CORRECTIVE MEASURES STUDY REPORT COMBINED SOLID WASTE MANAGEMENT  
UNIT 9 (SWMU 9) ZONE H CNC CHARLESTON SC  
3/1/2004  
CH2M HILL

## Combined SWMU 9, Zone H

Revision 1  
Contract N62467-99-C-0960  
158814.ZH.EX.06

**Figure 2-1**  
**Estimated Landfill Boundary**  
**Combined SWMU 9, Zone H**  
**Charleston Naval Complex**

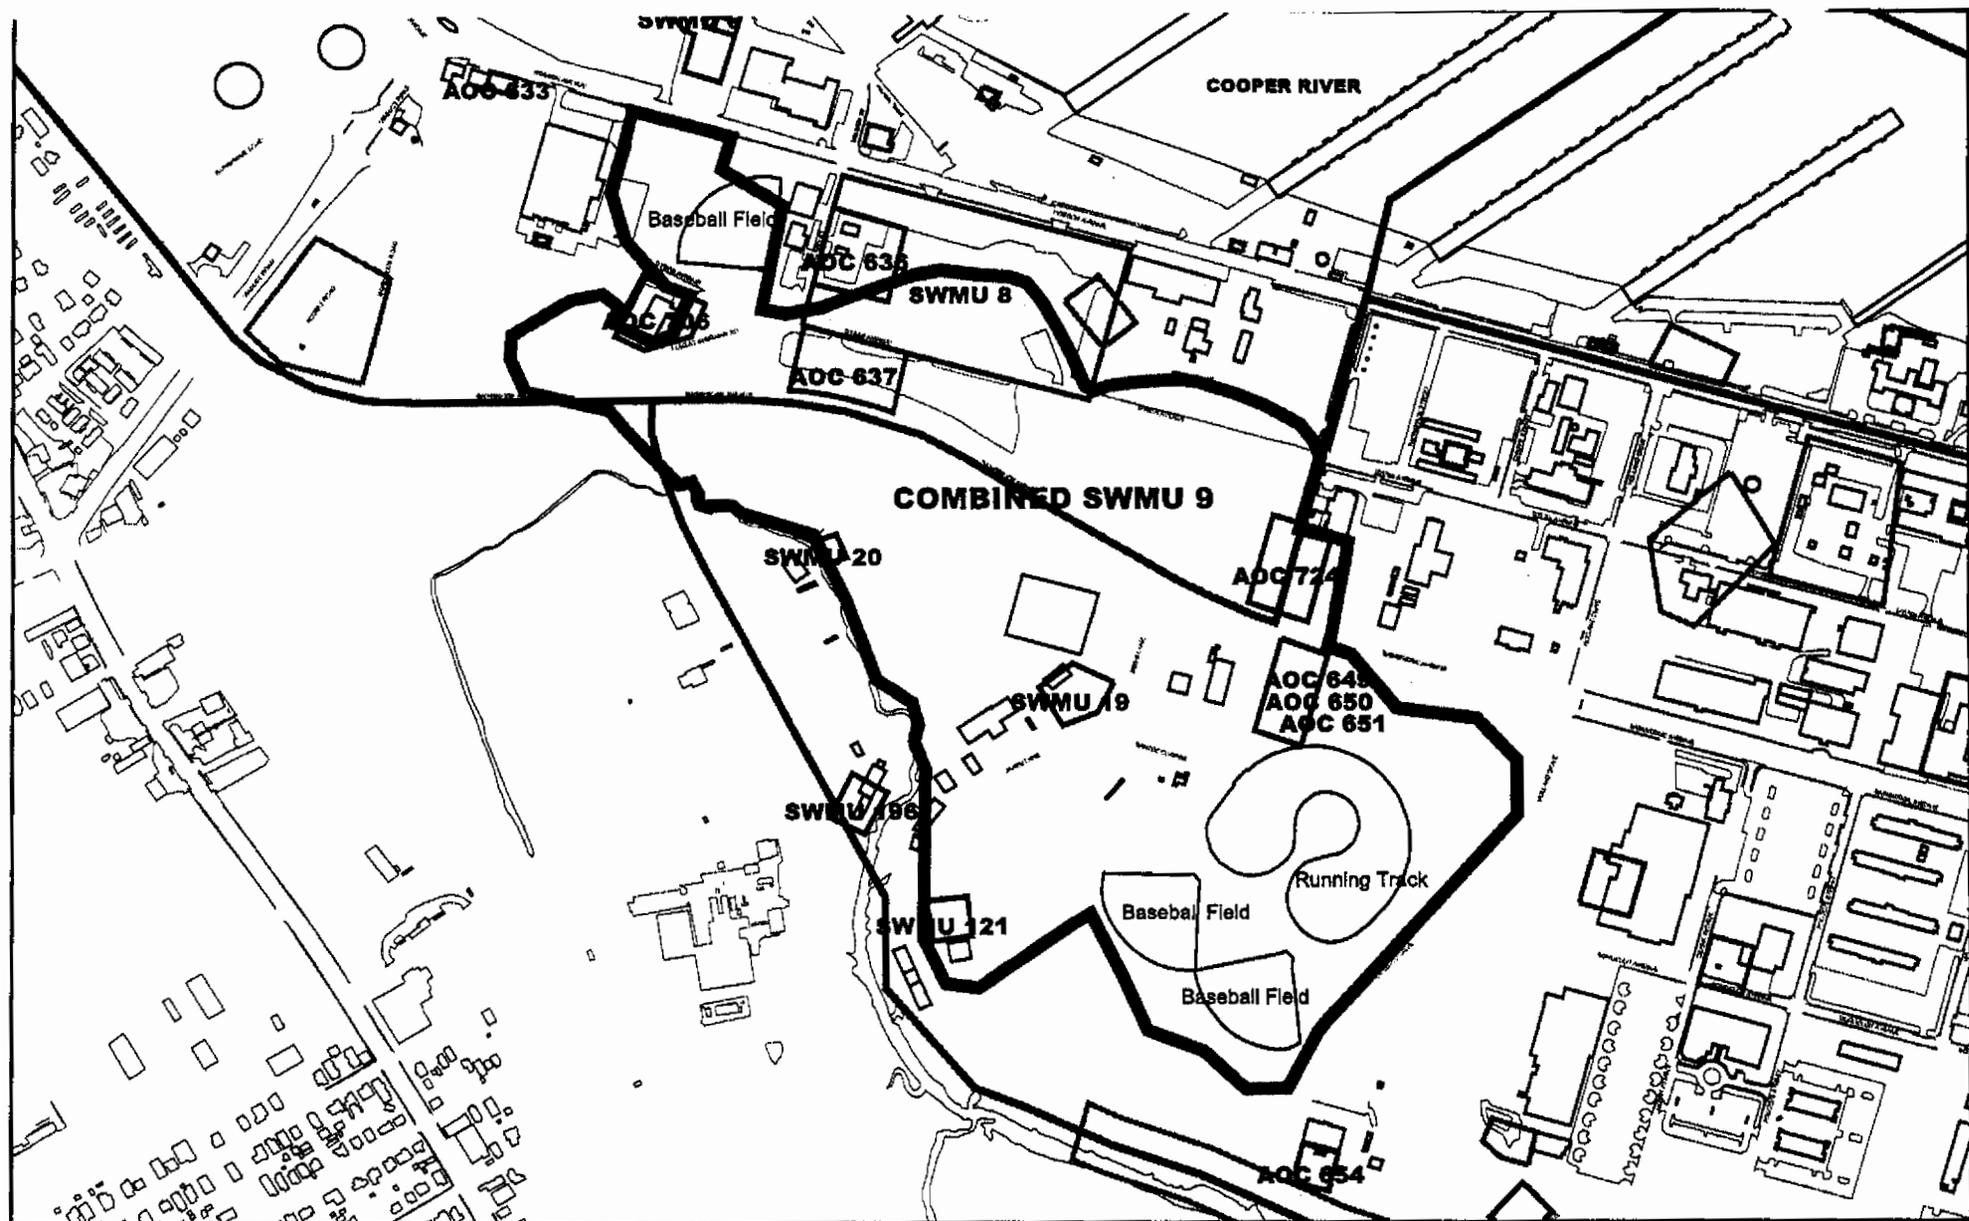
7. Reference is made to solid waste management unit (SWMU) 8 Oil Sludge Pit at the Parking Area Southwest of Building 61 and to area of concern (AOC) 654 Septic Tank and Drain Field Building 661 Area. The Navy should identify these units on Figure 2-1 entitled Combined SWMU 9 Estimated Landfill Boundary.

8. The Landfill boundary depicted on Appendix A Figure 1-2 does not match the boundary depicted on CMS Report Figure 2-1 entitled Combined SWMU 9 Estimated Landfill Boundary. Clarification of the unit boundary is needed.

10. Reference is made to AOC 636 Torpedo Magazine at Building 161. Please depict the site on Figure 2-1.

*Figure 2-1 will be revised to identify these units.*

*Figure 1-2 shown in Appendix A is being included as a reference to indicate the location of the test pits excavated by the Navy DET as part of the determination of the northern boundary of the landfill, whereas Figure 2-1 indicates the northern boundary proposed by the SWMU 9 CMS Report, Revision 0. The text in Appendix A will be revised to reflect this information, and Figure 1-2 in Appendix A will be noted to be consistent with Figure 2-1. The current estimated northern boundary of the landfill, based on the consensus opinion of the BCT, is shown in Figure 2-1.*

*Figure 2-1 will be revised to identify the AOC 636 location.*

**Figure 2-2**  
SWMU 9 Land Use  
Combined SWMU 9, Zone H  
Charleston Naval Complex

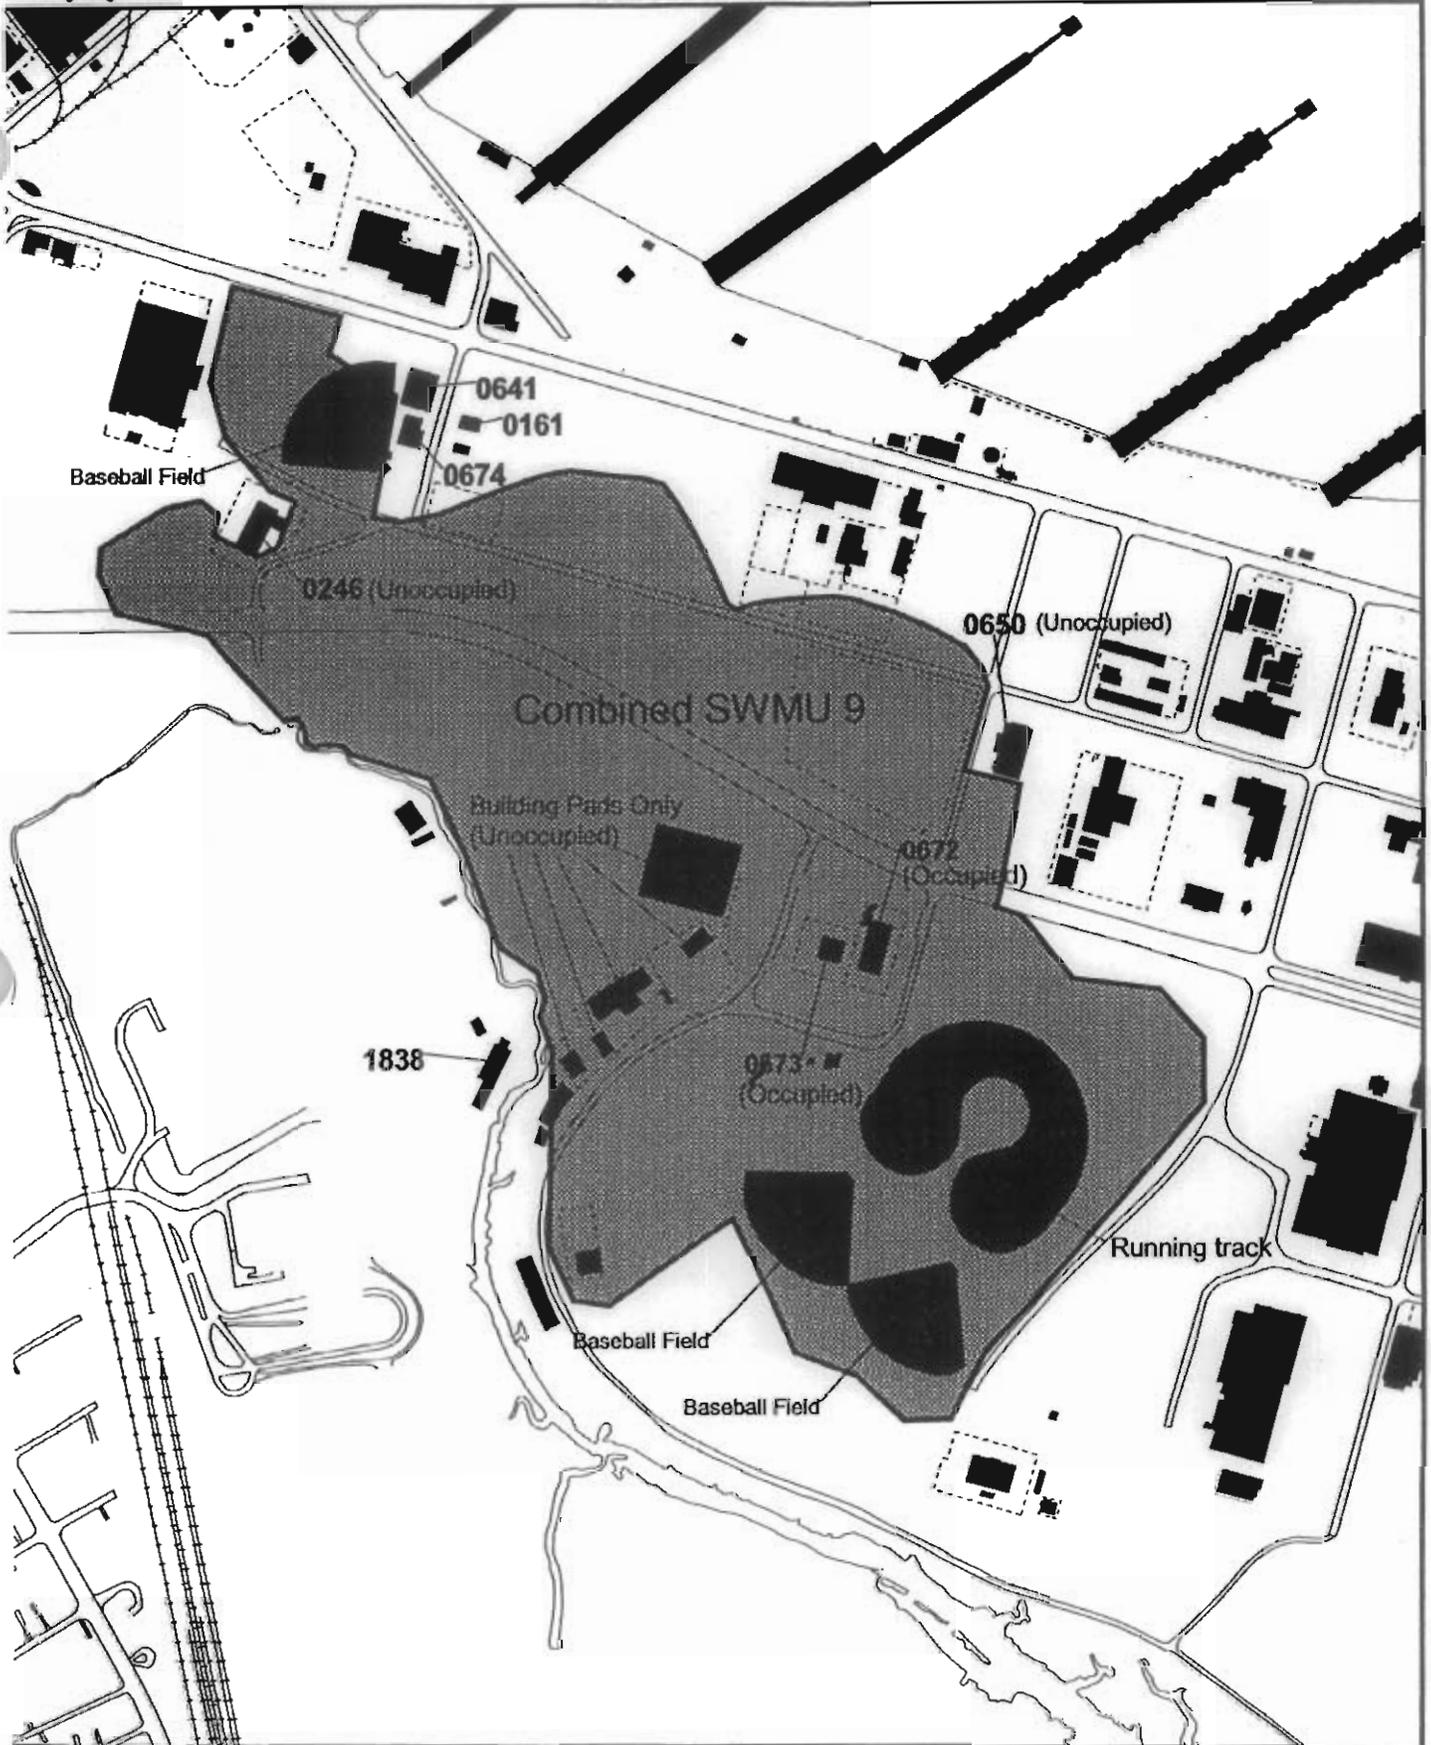
9. The text is vague in describing the "current" land use. The Navy states that a deed restriction will limit future development or land use to the "current uses". Moreover, referenced Figure 2-2 simply identifies three baseball fields, the running track, building pads and occupied Buildings 0672 and 0673. It is unclear whether the "Light Industrial" label on this Figure given outside the boundary east of the Landfill also applies to SWMU 9. The text should clearly state the intended reuse of this property and explain "limiting future development".

*Figure 2-2 will be revised to clarify the proposed land use zoning as it applies to Combined SWMU 9. The CNC EGIS (version 10.0) shows the various zoning codes. The Combined SWMU 9 boundary is included in the zone M-1 (marine light industrial). Please refer to the CNC Redevelopment Plan for additional information on the land use zones in this area.*

**Figure 2-8**  
 Potentiometric Surface Map-Shallow Groundwater  
 Combined SWMU 9, Zone H  
 Charleston Naval Complex

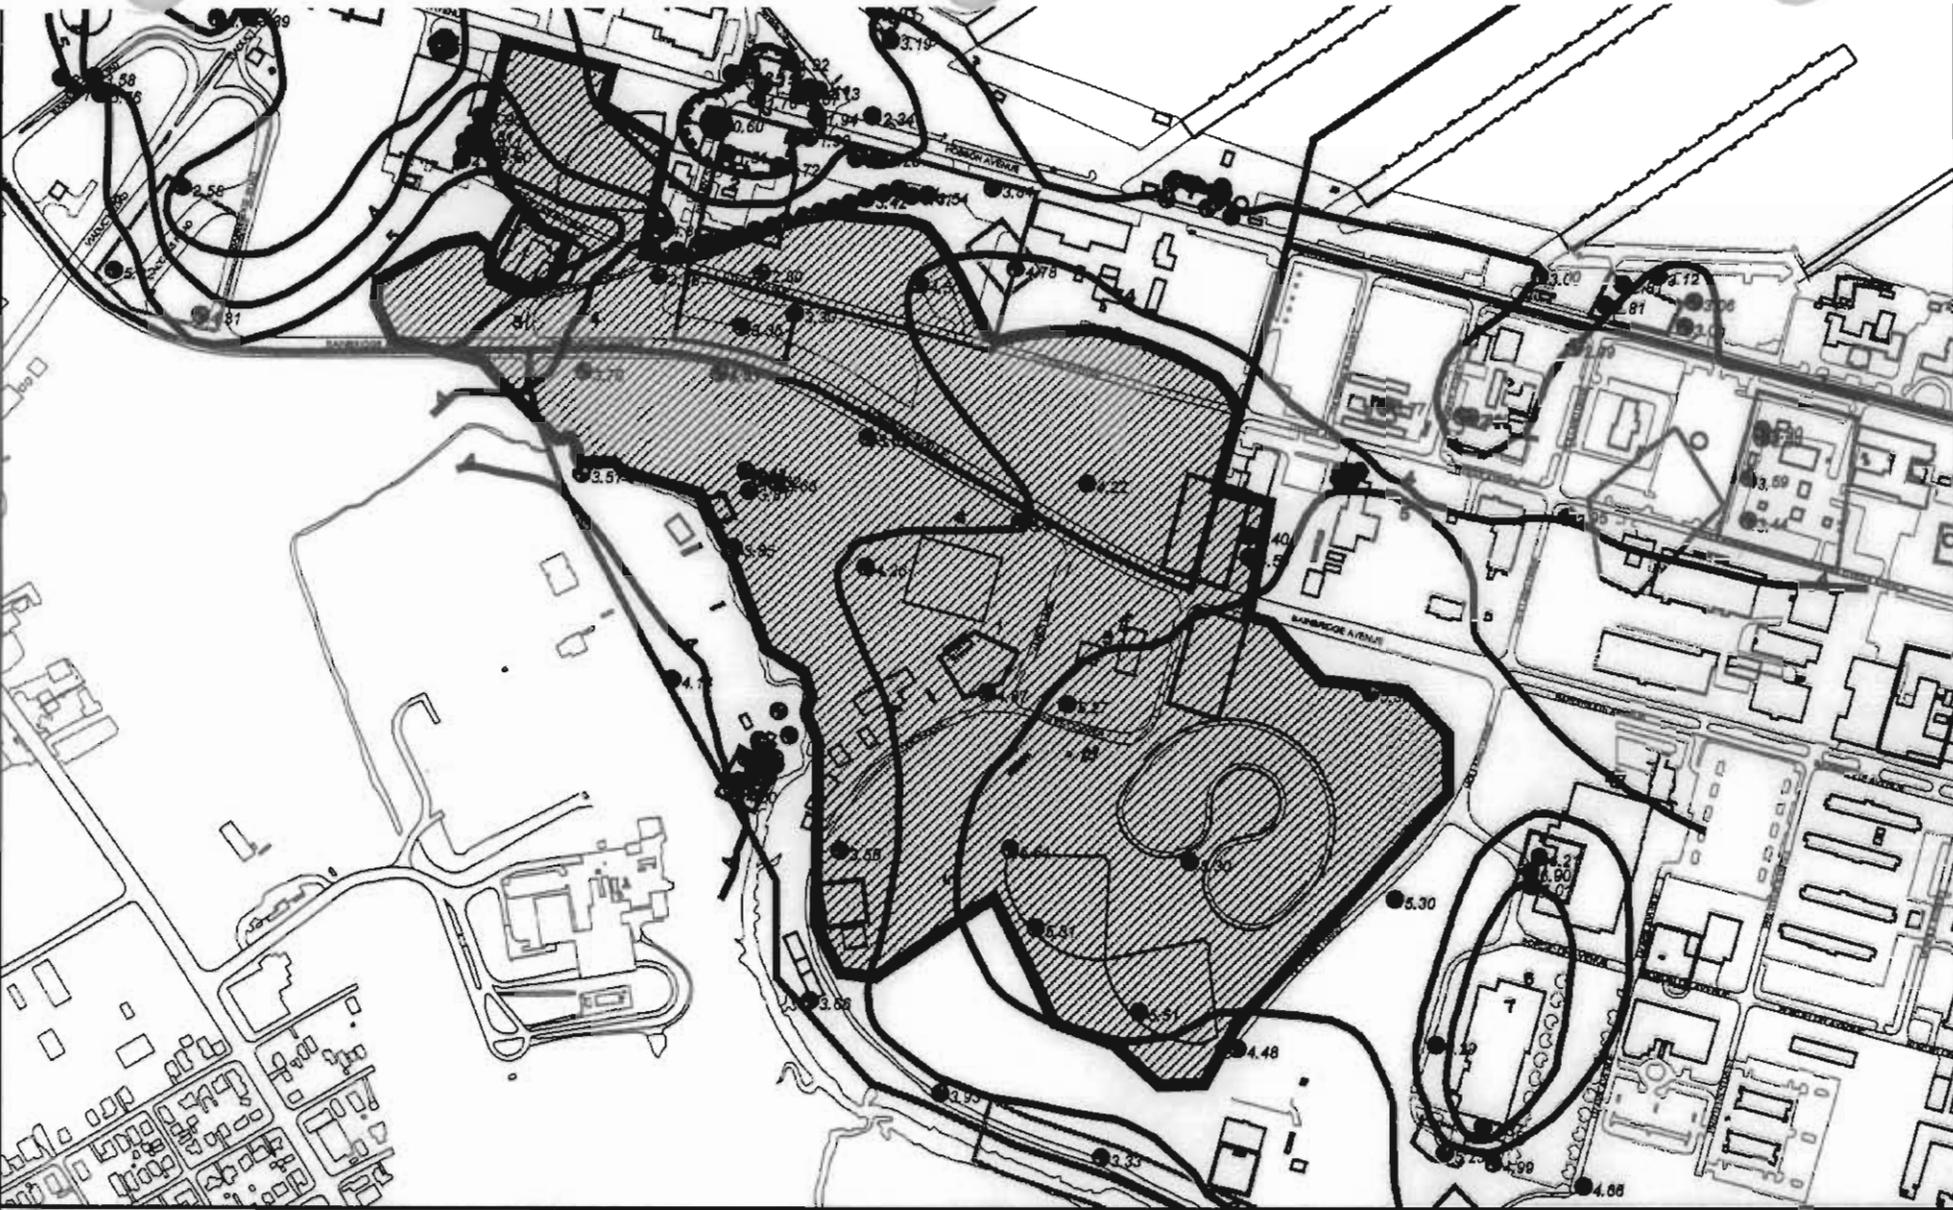
13. The entirety of Combined SWMU 9 must be depicted on Figure 2-8 entitled Potentiometric Surface Map - Shallow Groundwater.

16. Also, the text should be revised to more accurately and more clearly explain the direction of shallow groundwater flow. For example, the text states "groundwater flow in the central portion of SWMU 9 forms a trough that appears to flow to the north/northeast towards the Cooper River." The referenced "trough" is not evident from Figure 2-8. Another example: the text states that groundwater flow in the southeastern portion of SWMU 9 "flows radially to the north, west and south." The referenced southern component of flow cannot be deduced from Figure 2-8.

*Figure 2-8 will be revised to include the entire footprint of Combined SWMU 9 at a larger scale.*

*Figure 2-8 will be revised to include additional groundwater elevation contours to illustrate the description made in the text of the groundwater flow at Combined SWMU 9.*

**Figure 2-9**  
Potentiometric Surface Map-Deep Groundwater  
Combined SWMU 9, Zone H  
Charleston Naval Complex

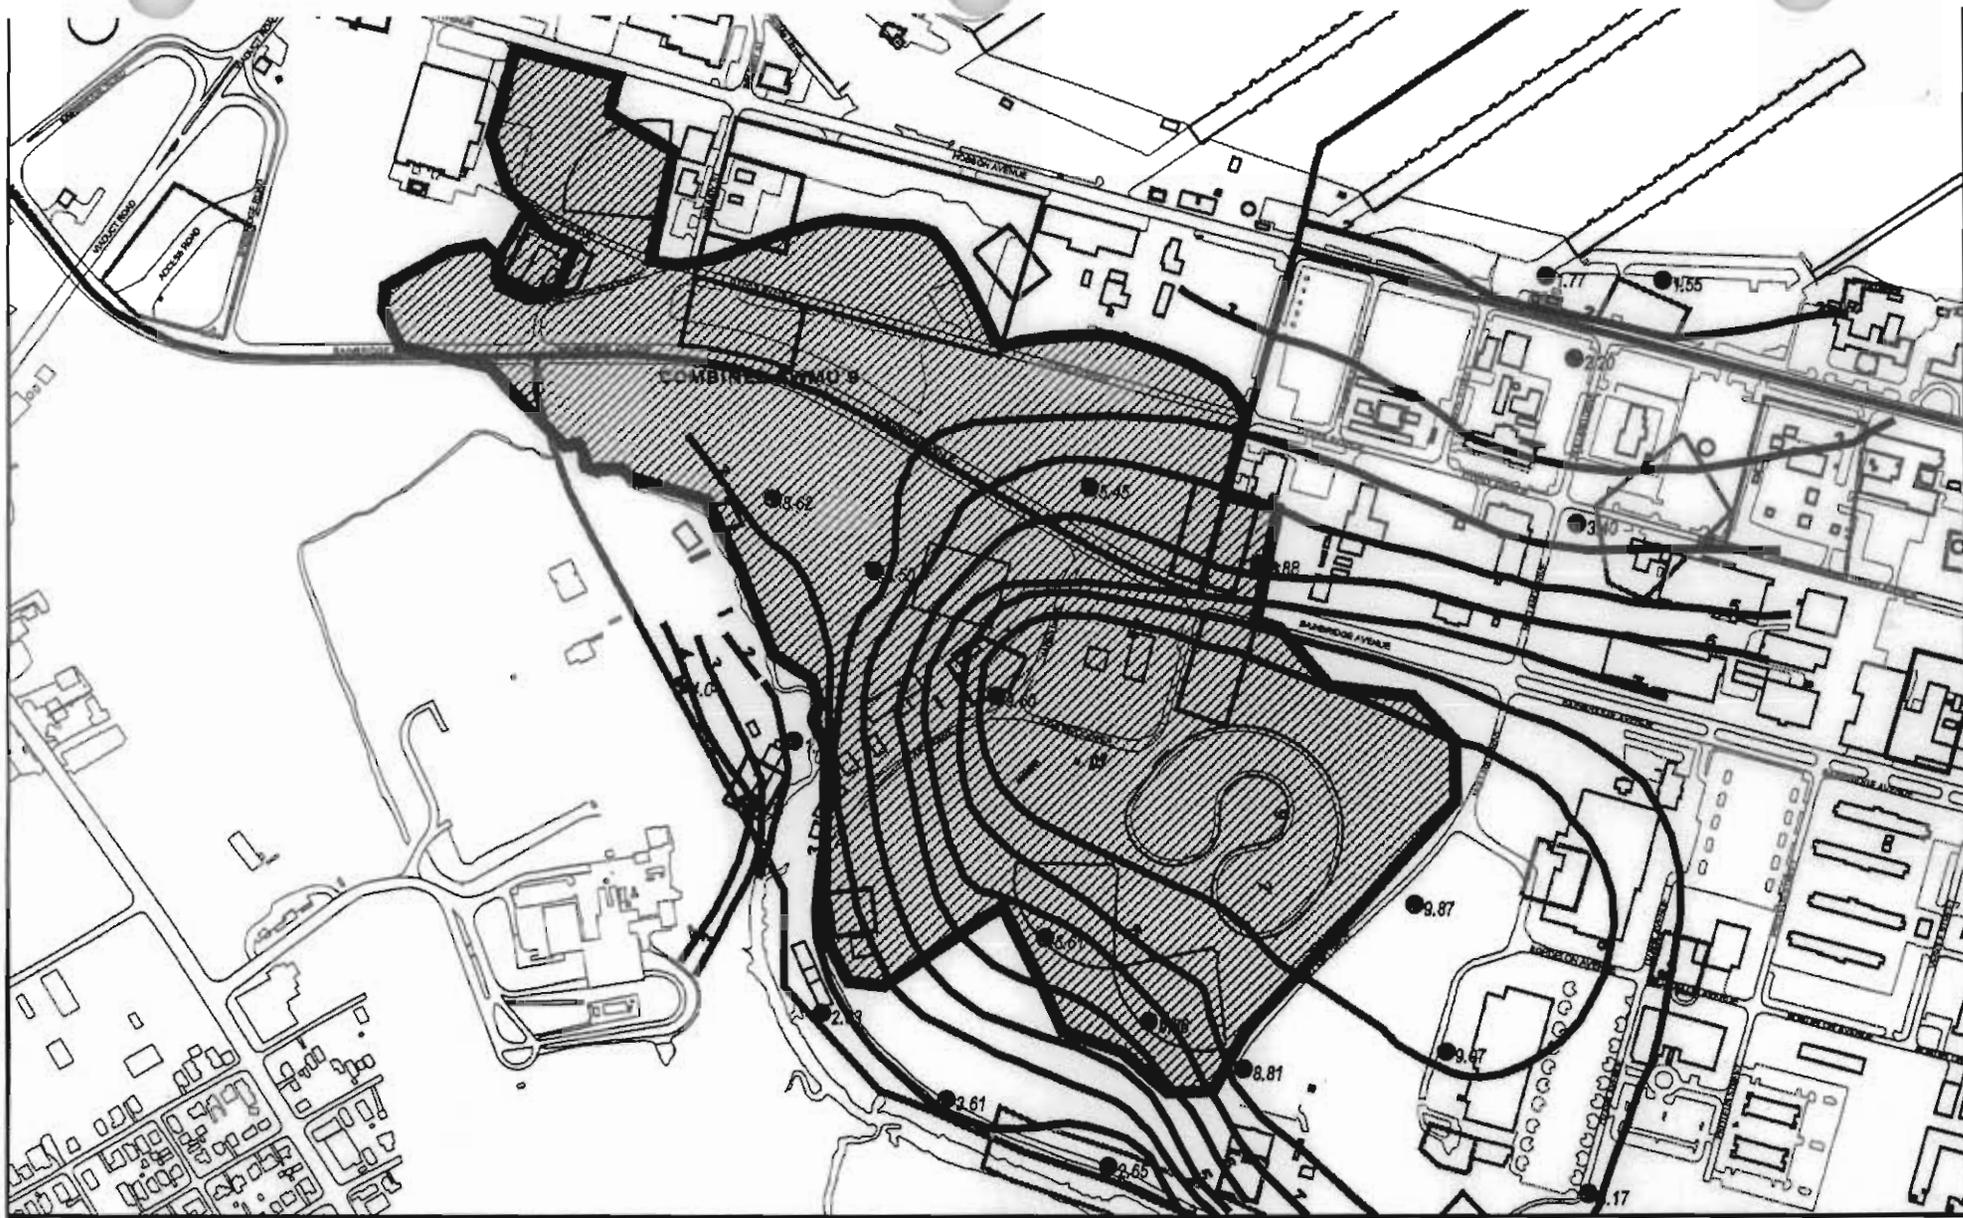
17. Deep groundwater flow in the northwestern portion of Combined SWMU 9 must be depicted on Figure 2-9 entitled Potentiometric Surface Map - Deep Groundwater.
